**Anthropomorphic Test Dummy; Six-Year Old Dummy**

**ACTION:** Final rule; technical amendment.

**SUMMARY:** This document makes a minor correction to the thorax assembly and test procedure in NHTSA's regulation for the six-year-old child dummy. This document corrects inconsistencies between the figure in the regulation that illustrates the test set-up for calibrating the dummy's thorax and the regulatory text that describes the calibration test procedure. This action removes potential sources of concern and confusion for manufacturers and users of the dummy about whether a particular six-year-old child dummy meets the specifications of NHTSA's regulation for the dummy (part 572, subpart I).

**FIGURE 41  
THORAX IMPACT TEST SET-UP**

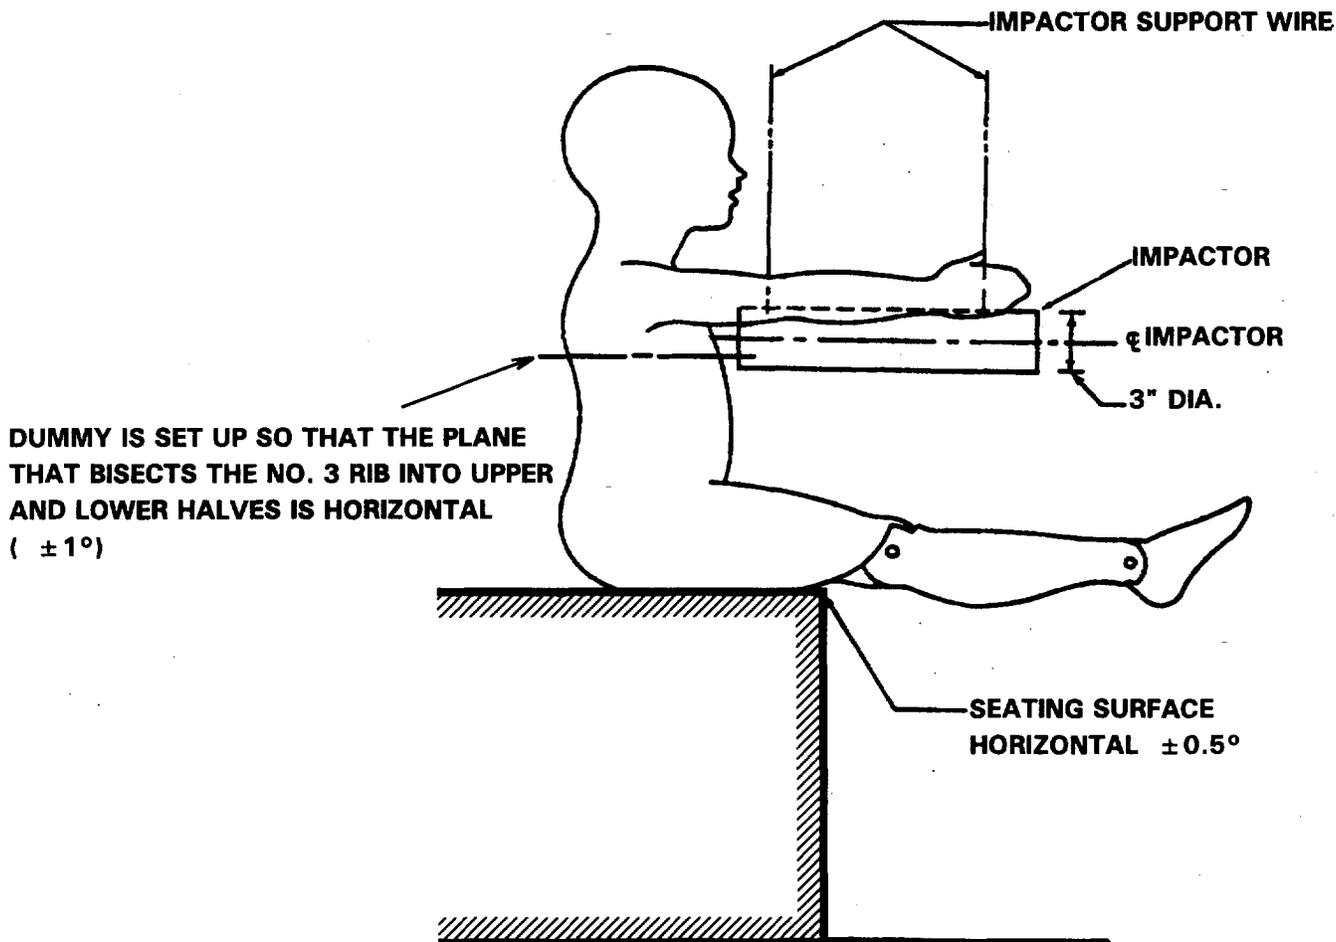
In February 1994, First Technology Safety Systems, Inc. (First Technology), a manufacturer of test dummies, informed the agency that figure 41 in subpart I appears to have two errors. Figure 41 illustrates the test set-up for calibrating the dummy's thorax (figure 41, "thorax impact test set-up"). Both errors are due to inconsistencies between figure 41 and the regulatory

The thorax test procedure [of section 572.74] states that the impact point should be 2.25 inches below the centerline of the clavicle retaining screw. The impact point based on that dimension would fall between the first and second rib. In contrast, figure 41 \* \* \* shows the centerline of the impactor in line with the centerline of the third rib.

The second error relates to how the dummy is positioned for the thorax impact test. Section 572.74(c)(2) specifies that the dummy is adjusted "so that the longitudinal centerline of the No. 3 rib is horizontal." In contrast, an instruction in figure 41 specifies that the dummy is set up with the centerline of the number three rib horizontal " $\pm\frac{1}{2}$  [inch]." First Technology stated in its letter, "[T]he tolerance on figure 41 is  $\pm\frac{1}{2}$  inch, which would result in 14 degrees variation."

NHTSA has examined First Technology's concerns and agrees that figure 41 and section 572.74 need to be amended so that they are consistent. As to the first error, the correct specification for the location of the impact point for the impactor is in section 572.74, and not in figure 41. The centerline of the impactor and the centerline of the third rib were drawn on figure 41 to be coincident instead of being slightly apart. This makes it appear that the impactor's first contact occurs at the centerline of the third rib, instead of approximately  $\frac{1}{8}$  inch above it, in accordance with section 572.74. NHTSA is correcting figure 41 to depict the centerline for the thorax impactor as being slightly above the depicted centerline of the dummy's third rib.

As to the second error, the instruction in figure 41 that specifies that the dummy is "set up with centerline of #3 rib horizontal  $\pm\frac{1}{2}$  inch" is inconsistent with the instruction in section 572.74(c)(2) concerning dummy set-up. The regulatory text states: "adjust the dummy so that the longitudinal

centerline of the No. 3 rib is horizontal." The " $\pm\frac{1}{2}$  inch" tolerance provided in figure 41 is inconsistent with the regulatory text since the centerline of the No. 3 rib of a dummy adjusted to the allowable limit could be far from horizontal. On the other hand, NHTSA believes that the tolerance should not be altogether eliminated. A 1 degree tolerance in section 572.74(c)(2) would provide some flexibility while ensuring that the centerline of the rib will be essentially, if not exactly, horizontal. Accordingly, NHTSA amends section 572.74(c)(2) to provide for  $\pm 1$  degree of tolerance. In addition, the instruction in figure 41 that specifies the dummy is "set up with centerline of #3 rib horizontal  $\pm\frac{1}{2}$  inch" is revised to provide for the  $\pm 1$  degree of tolerance.

The regulatory text of section 572.74(c)(2) is also revised with regard to its reference to the "longitudinal centerline" of the No. 3 rib as the portion of the dummy that must be horizontal. Using the word "longitudinal" is inaccurate, since "longitudinal" describes a characteristic of a line, while what was actually meant was the alignment of the dummy in a plane. To more accurately describe the positioning of the dummy, the direction in section 572.74(c)(2) that the "longitudinal centerline of the No. 3 rib is horizontal" is changed to "the plane that bisects the No. 3 rib into upper and lower halves is horizontal" ( $\pm 1$  degree). This text is also added to the instruction on positioning the dummy in figure 41.

(2) Establish the impact point at the chest midsagittal plane so that the impact point is 2.25 inches below the longitudinal center of the clavicle retainer screw, and adjust the dummy so that the plane that bisects the No. 3 rib into upper and lower halves is horizontal  $\pm 1$  degree.

3. Figure 41 in subpart I is revised to read as follows:
